**ADDENDUM NO. 1  
POND DR05 RESTORATION PROJECT**

**To: Tour Attendees**  
**From: Julie Andersen, Project Manager**  
**Date: June 26, 2014**  
**Re: Ponds DR05 Pre-Bid Tour Supplemental Information**

Project Name: Ponds DR05 Repair-  
10-80-830-8212

**6D DITCH RELIEF CULVERT (Typical)**

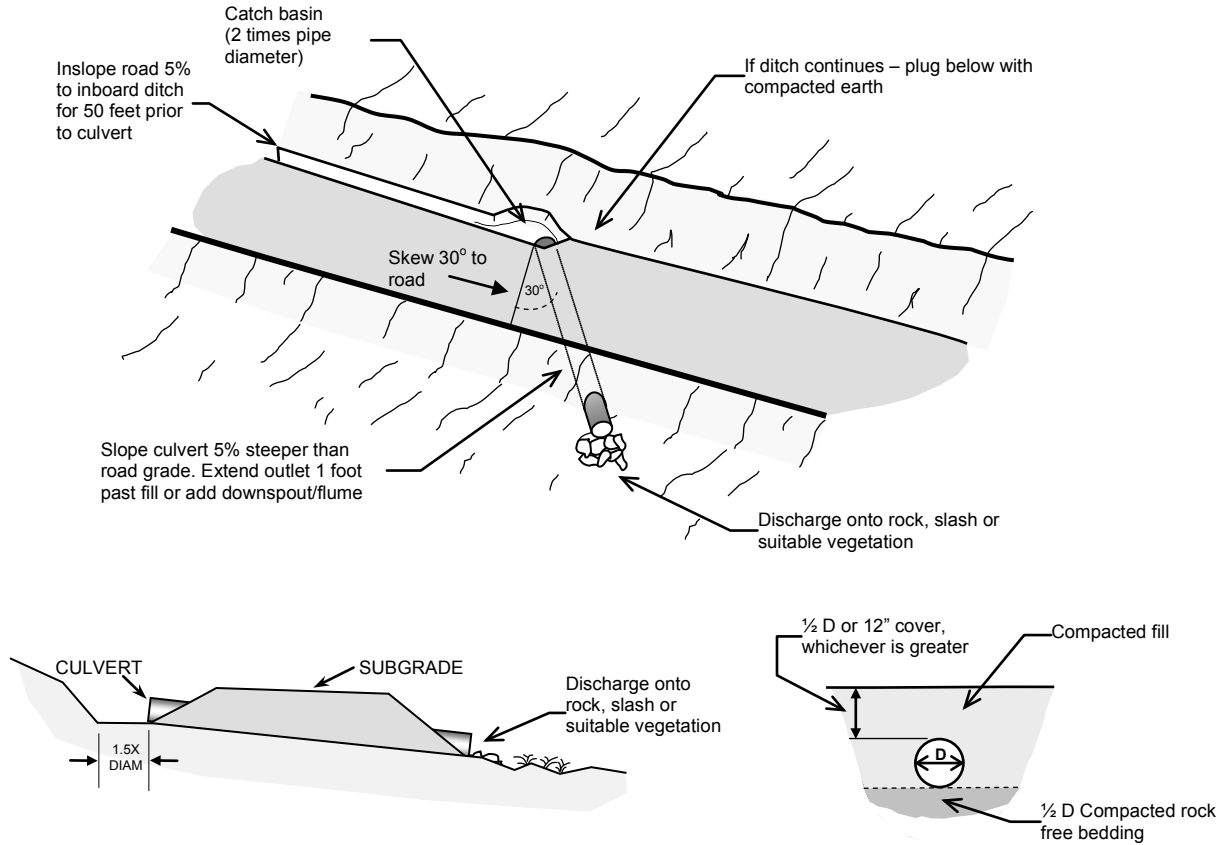
- Questions received on June 20, 2014 at the Pre-bid tour and District Response.
- Revised Attachment A1\_Bid Proposal (Please note three additional add alternate line items – items 10, 11, and 12).
- Ditch Relief Culvert Specifications (to be used when preparing bid for add alternate line item 11).
- Attachment P. Staff Gage Plans and Specifications (to be used when preparing bid for add alternate line item 12).
- Pre-bid tour attendee list

- Ditch relief culverts shall be installed flagged locations or as identified on plans. The maximum spacing of culverts shall be 150 feet unless otherwise specified or directed.

- Culverts shall be 12-inch diameter smooth bore, double wall HDPE (ASTM D3350 and AASHTO M294, Type S) unless otherwise specified
- The culverts shall be placed at a 30 degree skew angle down grade (where allowable) with a gradient 5% steeper than that of the road. Culverts should extend a minimum of 1' beyond base of road fill.

- Where necessary, outlet ditch shall be constructed at a steeper gradient than the culvert, at least one pipe diameter in width, and with bank tapered back to a 1:1 slope.

- The culvert bed shall ½ diameter of the culvert and be clean and free of large woody debris and large rocks. Trench shall be adequate width to facilitate compaction.

- Select approved mineral soil shall be used for culvert back fill. The back fill shall have no rocks greater than 3 inches in any dimensions placed closer than 1 foot to the culvert. Backfill shall be adequately compacted throughout the entire process to 95 percent ASTM 1557 unless otherwise specified. During placement and compaction of fill, the moisture content of the materials being placed shall be maintained.

- Compacted fill coverage shall be minimum ½ pipe diameter or 12 inches, whichever is greater
- Rock, slash or suitable vegetation should be used at discharge point as directed or specified

- A ditch block shall be placed immediately downslope of the culvert intake to prevent ditch flow from bypassing the pipe inlet.
- Specifications are indented only as guideline, modifications may be made in the field by geotechnical consultant or designee

**STAFF GAGE INSTALLATION DETAIL** (1)  
SCALE: 1" = 10'

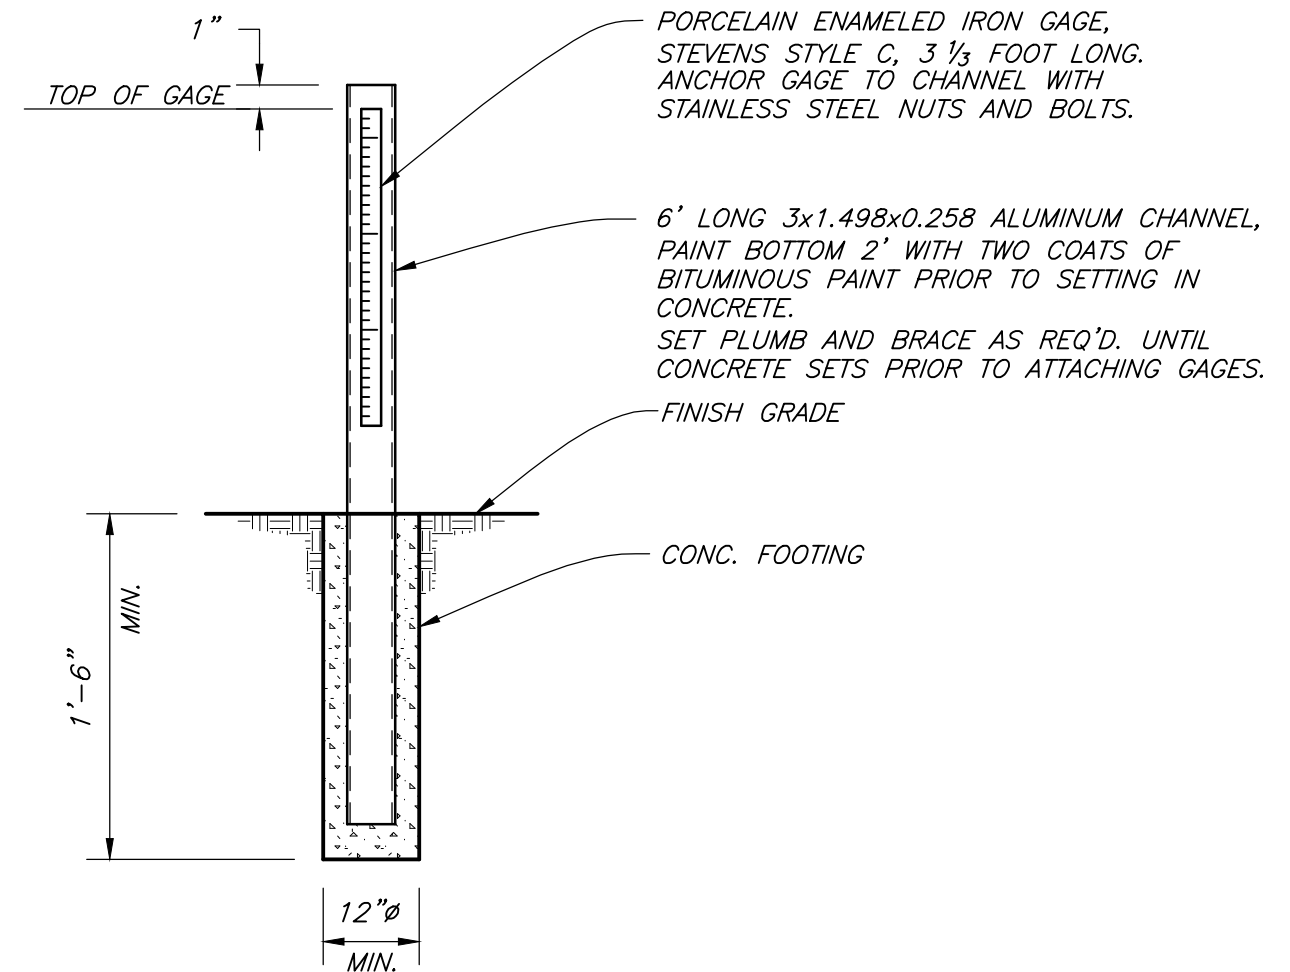
12.	Install staff gage according to Attachment P. "Staff Gage Plans and Specifications" Actual location within the pond is flexible and is to be determined in the field.	LS

The selected contractor is requested to bid on installation of a staff gage according to the following directions/specifications, or equivalent, as approved by project engineer.

**NOTES:**  
THIS PLAN IS FOR A RESERVOIR DEPTH OF ABOUT 36 FEET. SHALLOWER RESERVOIRS WILL REQUIRE FEWER GAGE ASSEMBLIES.  
TOP OF GAGES SHALL BE LEVEL WITH THE BOTTOM OF NEXT UP-SLOPE GAGE.
